Crime Impact Statement

Former Pemberton Colliery, Foundry Lane, Wigan

202 no. Houses

2011/0358/CIS/01

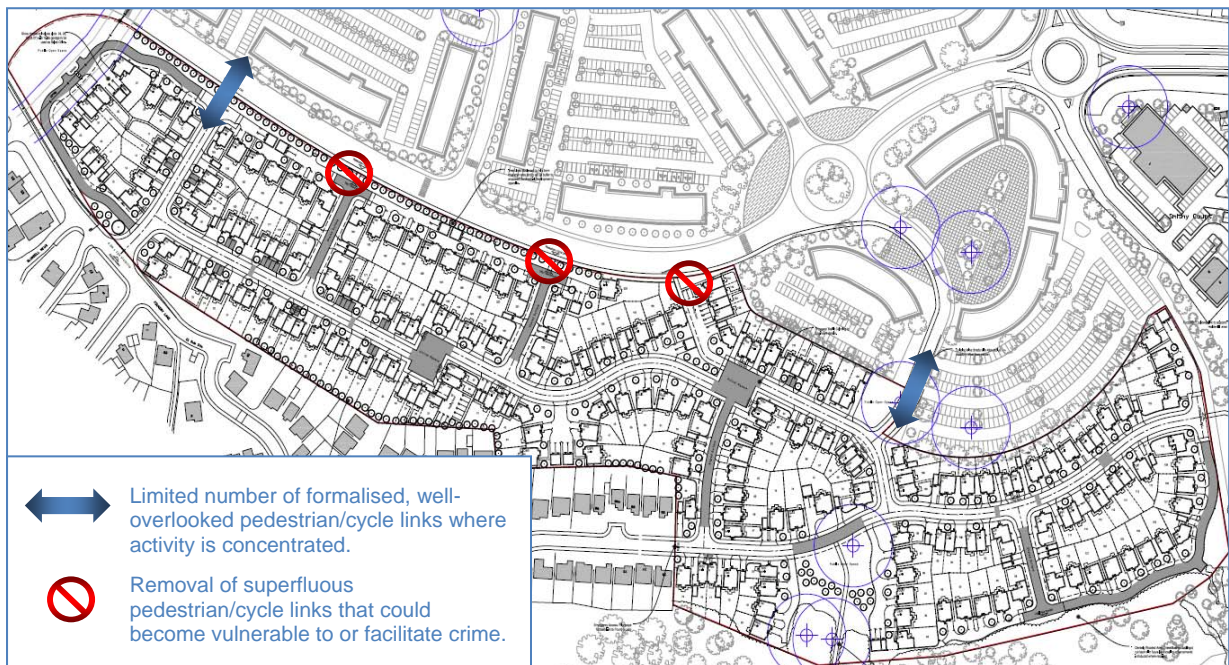
- 5.2.1 Careful consideration should be given to the need for multiple pedestrian/cycle links to the commercial development to the north and the adjacent open space to the south and east, which can provide easy access/escape routes for criminals and leave adjacent dwellings and parked vehicles vulnerable to attack. It is also likely that such routes could be exploited by criminals to attack/escape from the adjacent proposed commercial buildings and large surface parking areas.

- 5.2.2 If such links to the commercial development to the north are considered absolutely necessary, I would recommend they are reduced in number to the minimum practicable (illustrated on the plan below), creating formalised, well-overlooked access points set well-away from any immediately adjacent properties or parking spaces. Limiting the number of connections can make a development less likely to attract crime (leaving criminals feeling more vulnerable to detection) without compromising permeability.

- 5.2.3 Given the information provided by the local CRA (see Section 2.7) in relation to the existing problems experienced in the locale, the proposed footpath/cycleway links to the south (linking to Smithy Brook) and east (linking to an adjacent residential area) of the development should be carefully considered. Where possible, it is always preferable not to have segregated routes for pedestrians, cyclists and vehicles. I would suggest that pedestrians/cyclists would be safer using the proposed/existing road network to access the areas to the east of the development, rather than a secluded footpath link that may foster crime and anti-social behaviour and could leave legitimate users vulnerable and intimidated. If the link to Smithy Brook to the south is to remain, it should be as straight and as wide as possible wide, with unimpeded views both of and along it, and it should also incorporate measures to deter unauthorised motorcycle access.

- 5.2.4 The dwellings on the edges of the scheme (i.e. adjacent to the commercial scheme to the north and areas of open space to the south and east) are a little remote and isolated from the rest of the development and will not benefit from as much natural surveillance - this may leave them perhaps more vulnerable than those located within the heart of the scheme. It is highly recommended that the edges of the development are defined by 1500mm high railings, deterring casual/uncontrolled access and limiting legitimate access to the formal links described above.

- 5.2.7 Any driveways/garages provided to the rear of individual properties (e.g. at Plots 15, 17 etc.), where vehicles would be hidden from view from the residents themselves, should be incorporated into the rear gardens of the dwellings behind fencing/vehicular gates (see Section 6.5).

- 5.2.8 I would be concerned if the rear parking court serving Plots 34-39 is to be left open and accessible to all, leaving the parked vehicle and the rear of dwellings vulnerable, where they could be attacked unseen from the street. The rear parking court must be robustly enclosed and gated to prevent unauthorised access (see Section 6.5) and there should be no visitor spaces provided in this area. The front parking court serving Plots 148-151 should have a different surface colour/texture from the street, encouraging a feeling of territoriality among residents and psychologically giving the impression the area is private, discouraging access to anyone without a purpose from entering.

- 6.5.2 The rear parking court serving Plots 34-39 should be enclosed with 2100mm high automatic vehicular gates, operated by a key fob/proximity reader system with no automatic egress (i.e. access control both 'in' and 'out') so that criminals cannot gain access to the areas, attack the vehicles and escape. There should be no centrally located horizontal bars to aid climbing and the gates should be located away from other climbing aids, such as low walls, street lights etc. The hinges should also not provide footholds and the gap at the bottom of the gates should be small enough to stop anyone crawling through. If double gates are used, they should overlap when closed and should not be capable of being forced open.

- 6.5.4 The rear boundaries to gardens adjacent to any rear parking court (i.e. Plots 37, 39 & 41) could be 1800mm high and should be partially visually permeable (e.g. 1200mm solid panel with 600mm integrated robust trellis above) to allow some surveillance through. Gates into the rear curtilages of dwellings should be in keeping with the height of adjacent boundary treatments and should be lockable from both sides (i.e. with a key operable deadlock), to allow residents access to/from the parking court.
